DESIGN AND CONSTRUCTION MANUAL DESIGN MODIFICATION REQUEST

PROJECT NAME: LSR7 Middle School #4 – Bailey Road

PERMIT NUMBER: PL2020134

Re: LSR7 Middle School #4 Stream Buffer Variance - PL2020209
Stream Assessment Design Memorandum

STREAMWAY CENTERLINE PROFILE
 NATURAL CHANNEL ASSESSMENT

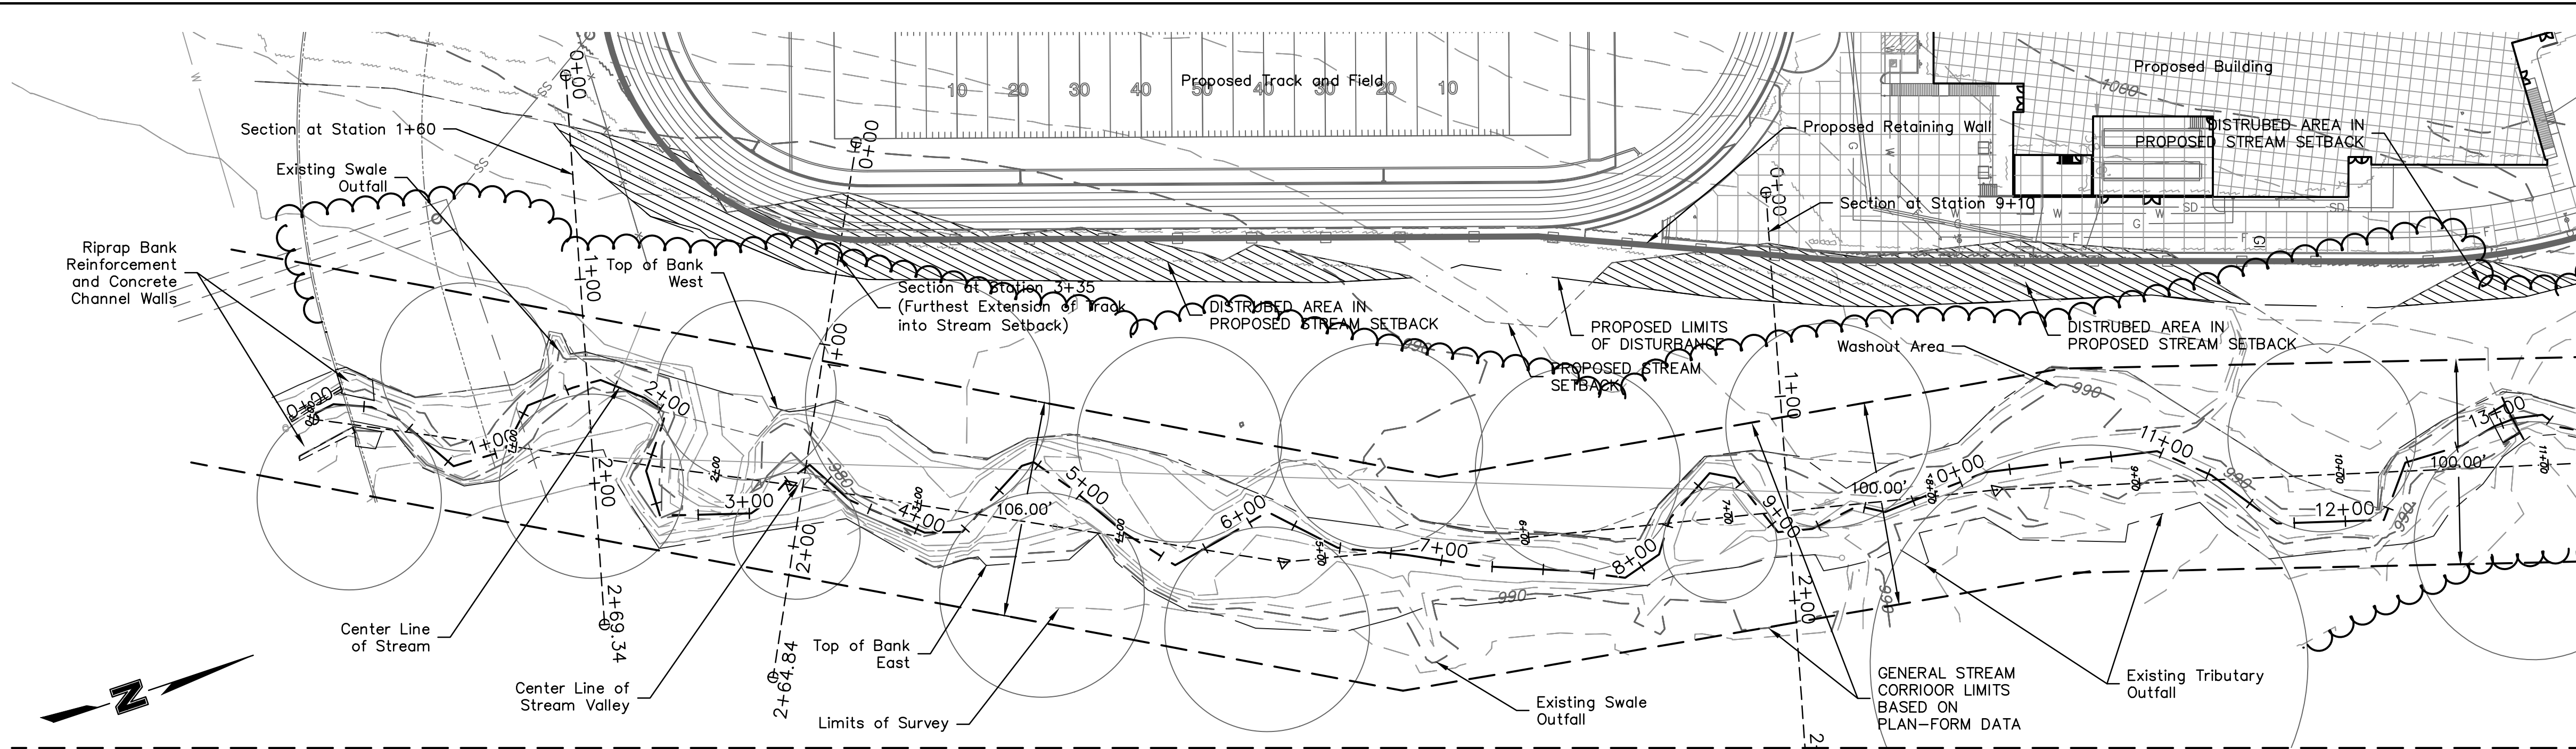
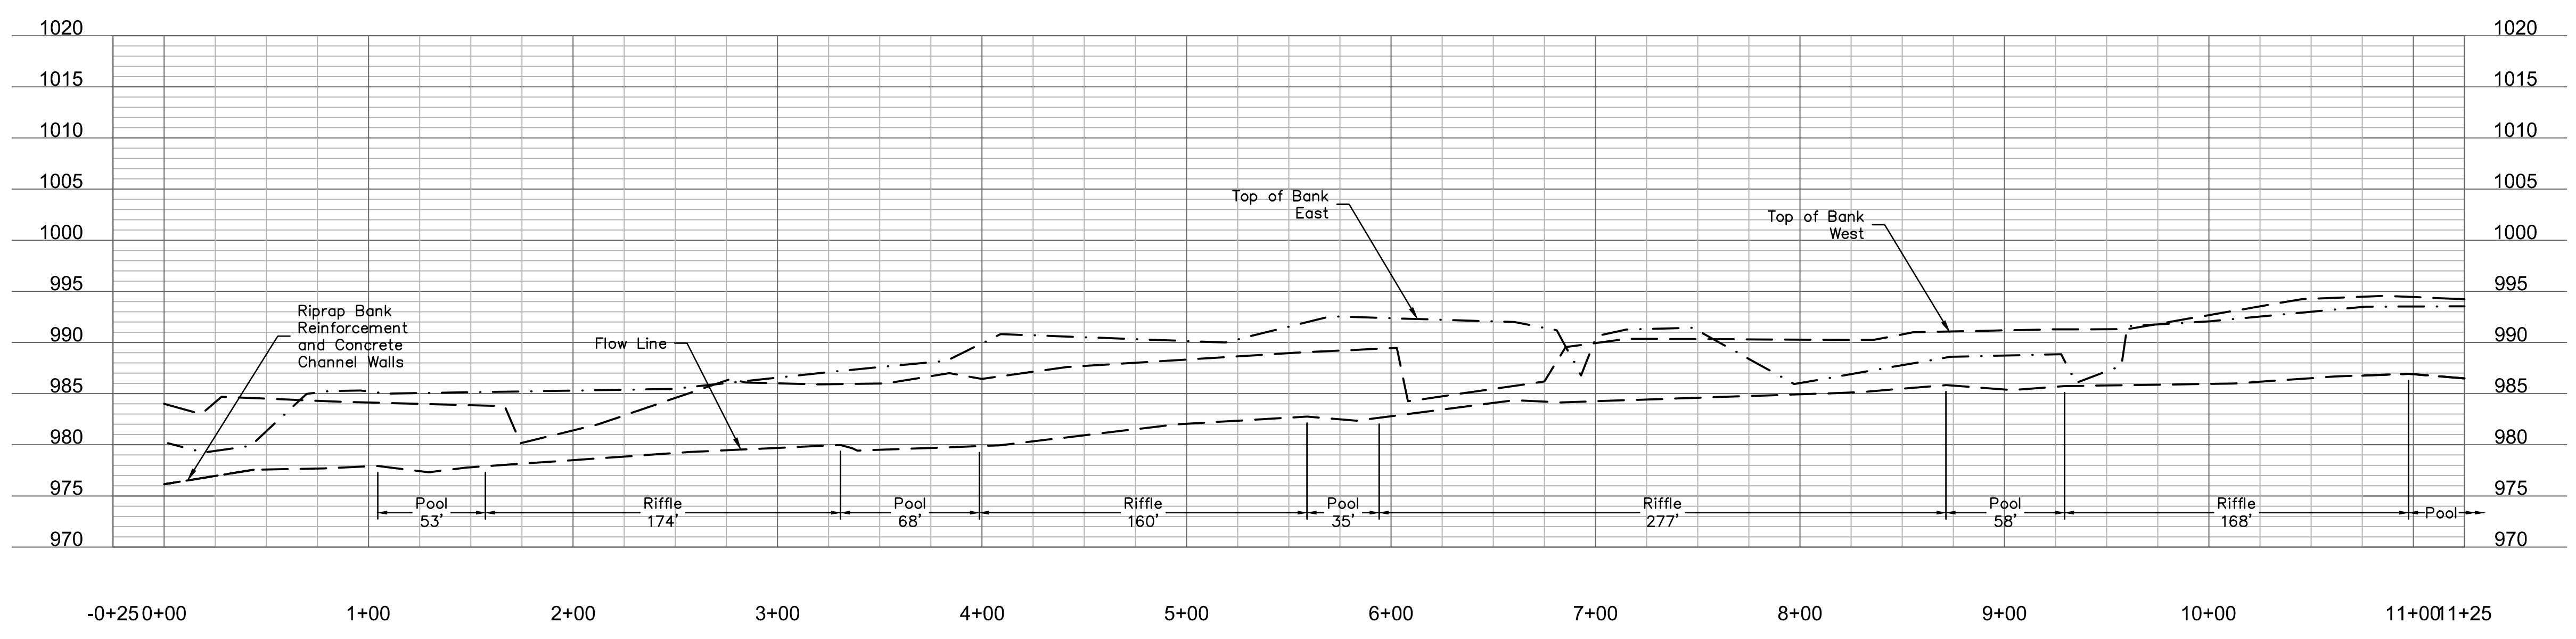
The existing stream information and the plan-form analysis have been shown are the attached Stream Assessment Drawings. The Plan-Form Ratio lies with the typical range with the exception of meander length/full bank width.

This could be explained in the outfall from the enclosed storm system coming under Bailey Road. The north end of the stream where the outfall is located shows a lower sinuosity than the south end of the stream. There two concrete flumes or checks (Sta. 13+05, Sta. 23+80) constructed in the stream. The checks are immediately downstream of locations where natural swales enter the channel. Finally, a structure has been constructed in the stream at the south end of the property. The structure consists of riprap bank protection on each side of the stream and concrete channel walls. These structures would tend to anchor the stream in its current location.

Based on the plan-form analysis, general stream corridor limits have been shown on the Stream Assessment Plans. The stream corridor limits show that the proposed construction will not interfere with the natural meandering of the stream.

STATION 17+66 (0+00 - 2+50)

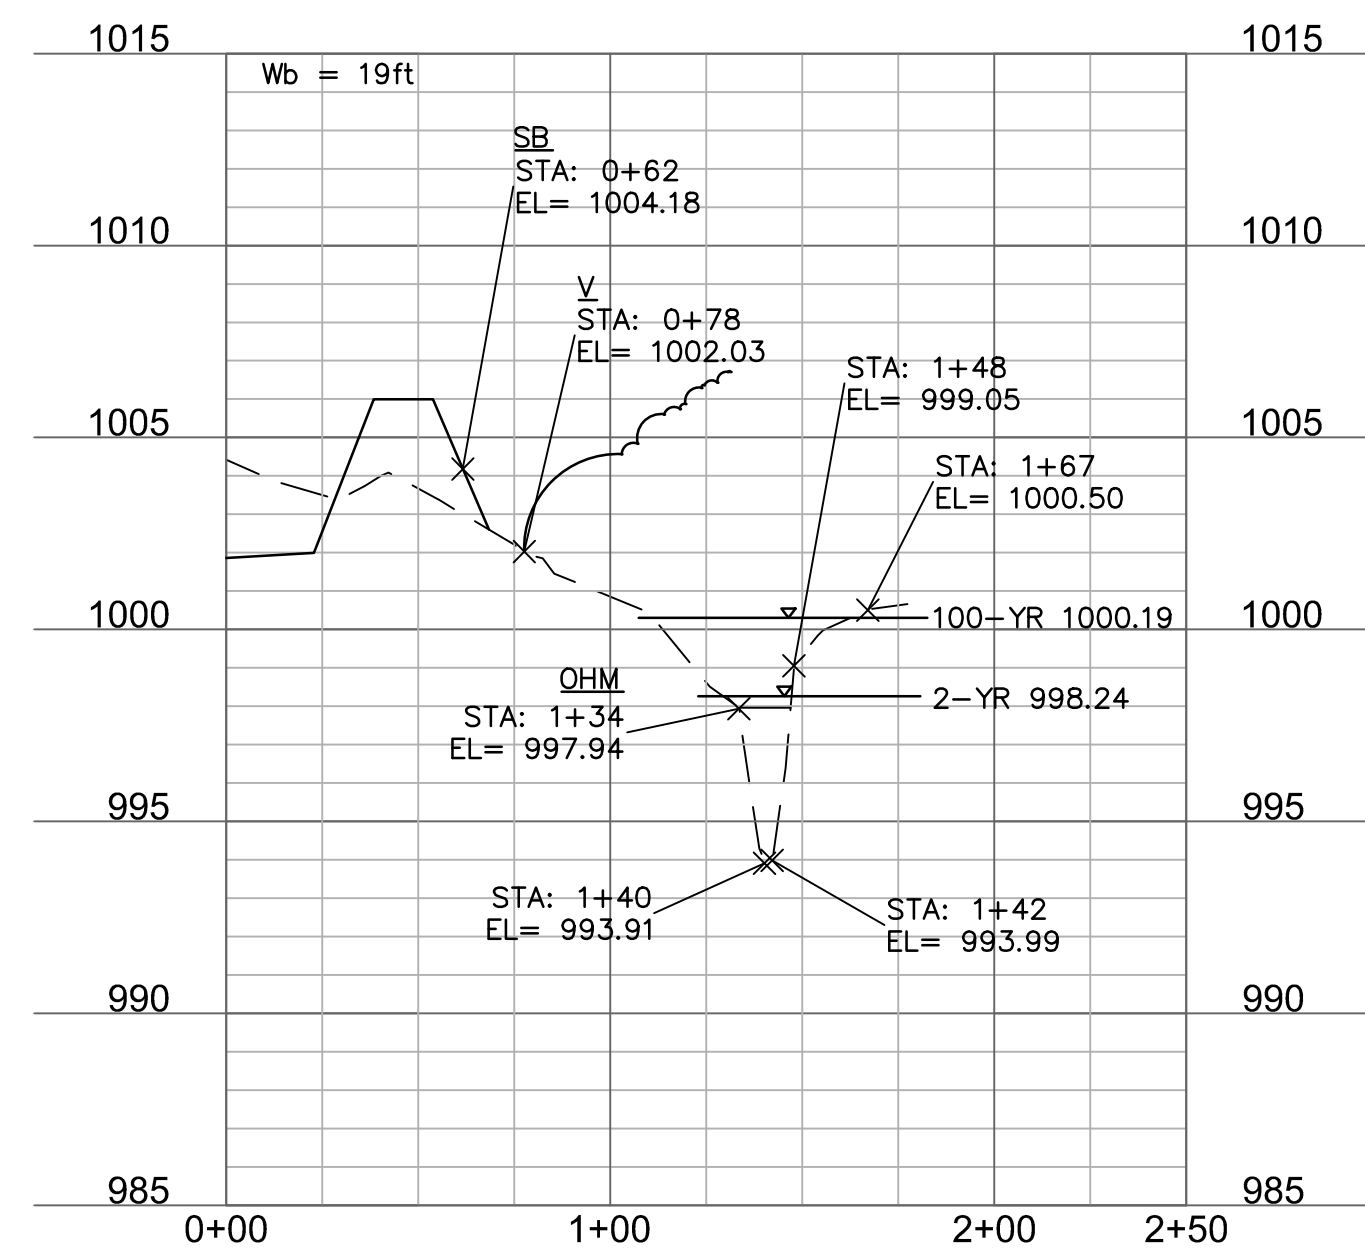
There will also be 2 permanent energy dissipation structures (riprap outfall protection and ditch checks) installed at Station 17+66 and Station 22+40 to prevent erosion from the outfalls of Detention Basins EDD-1 and EDD-2. The dissipation structures will be located within the permanent stream setback area.

STATION 22+40 (0+00 - 2+50)

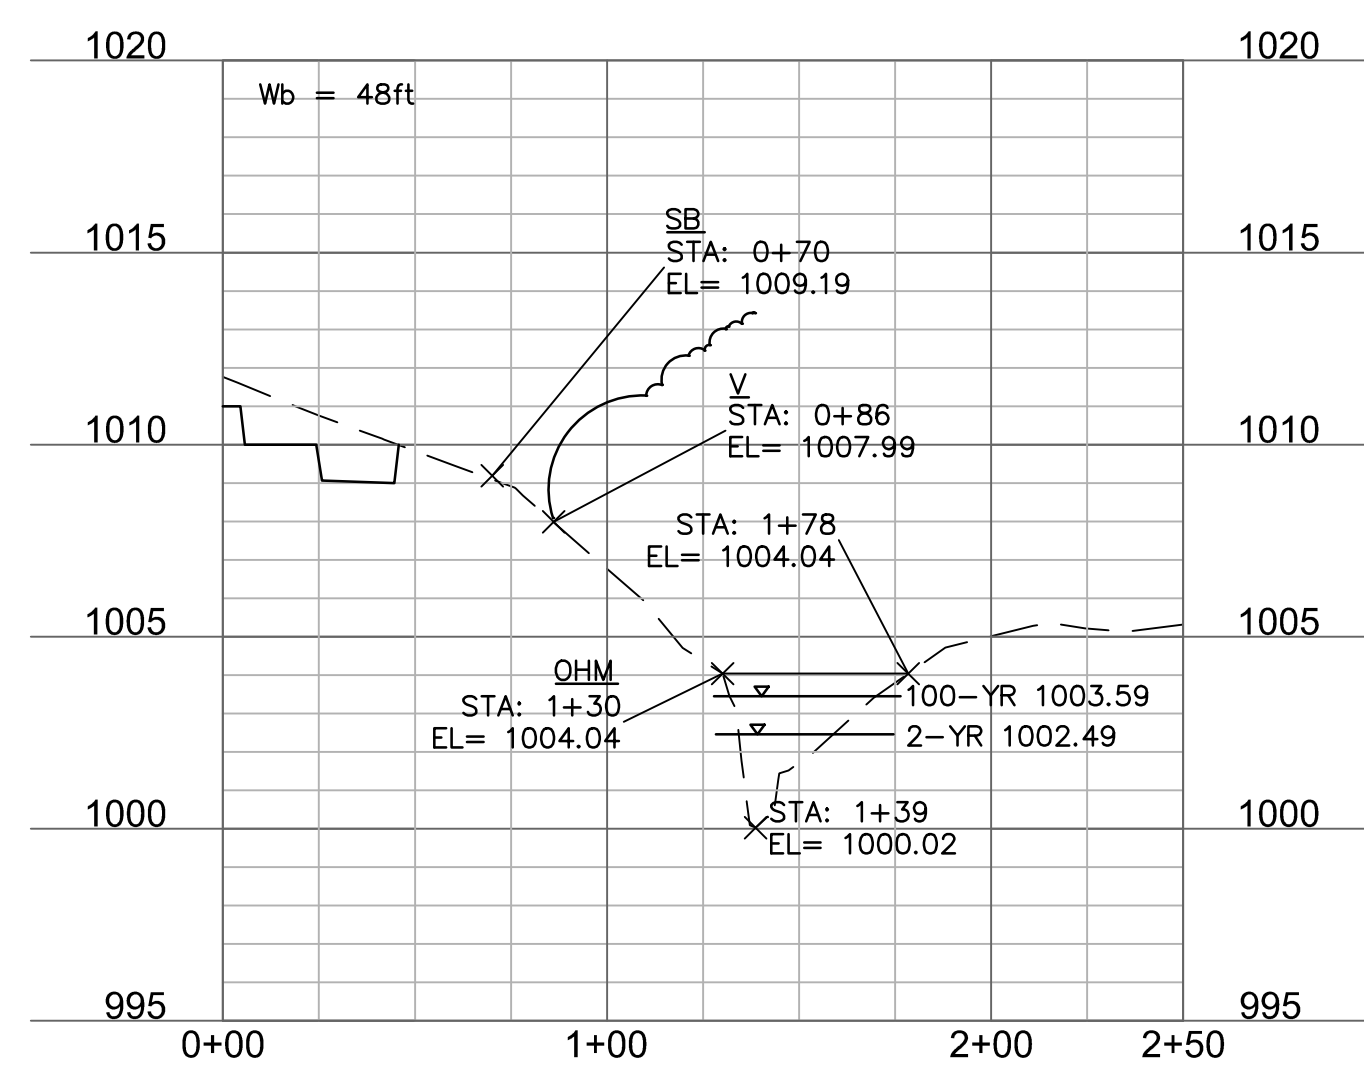
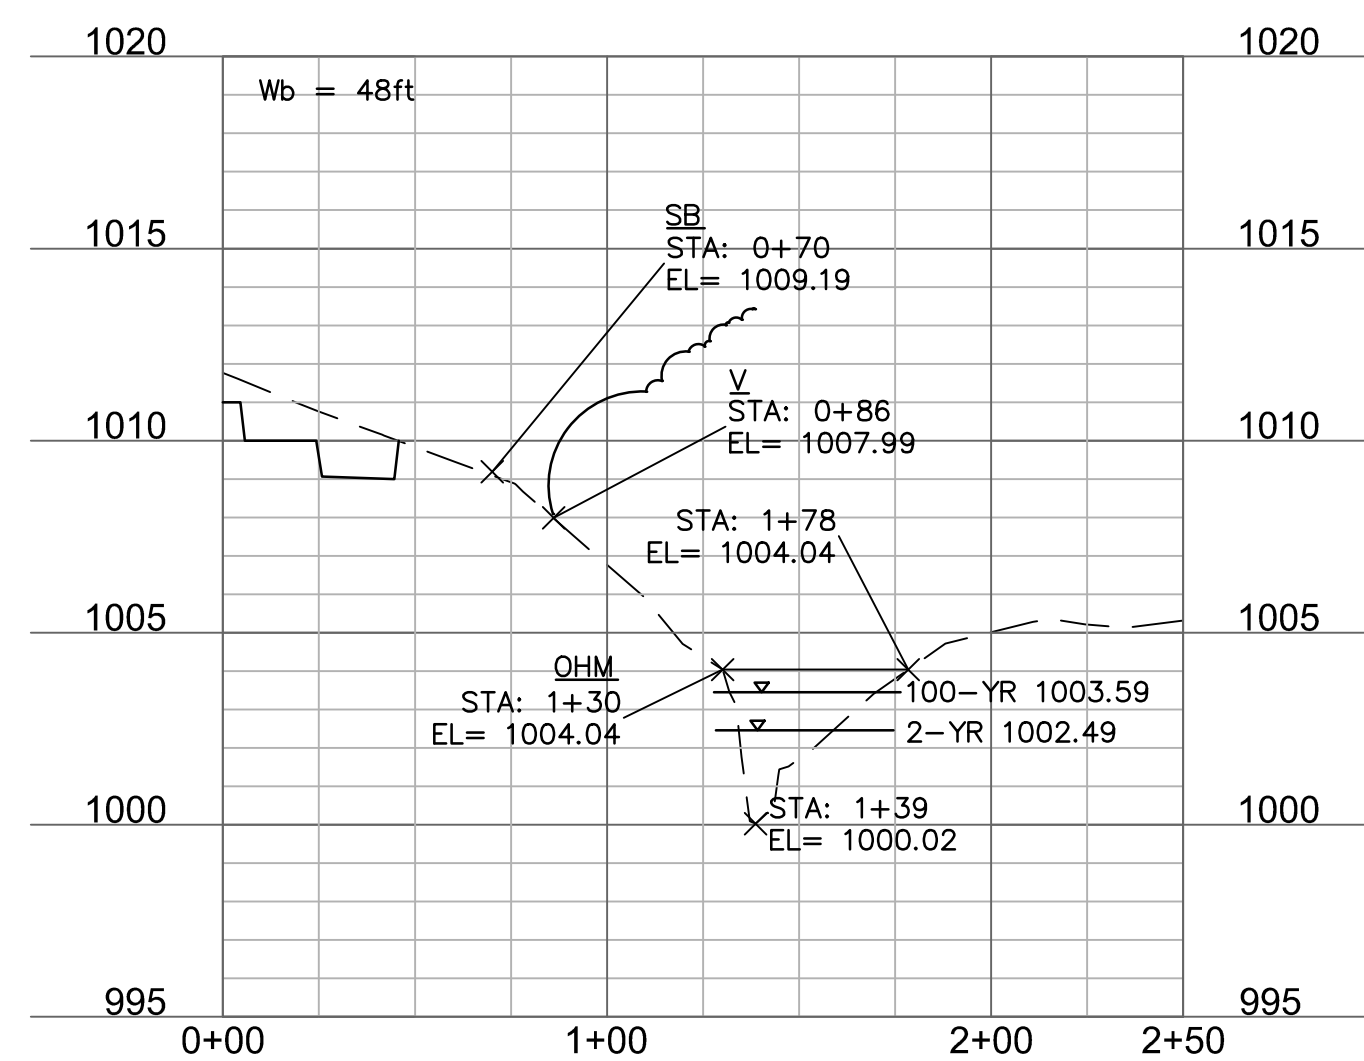
The post construction applied shear stress was also compared to critical shear stress for the bed material. This ratio is shown in Table 5. It indicates the bed material is stable, with the exception of Station 22+40 in the 100-year storm.
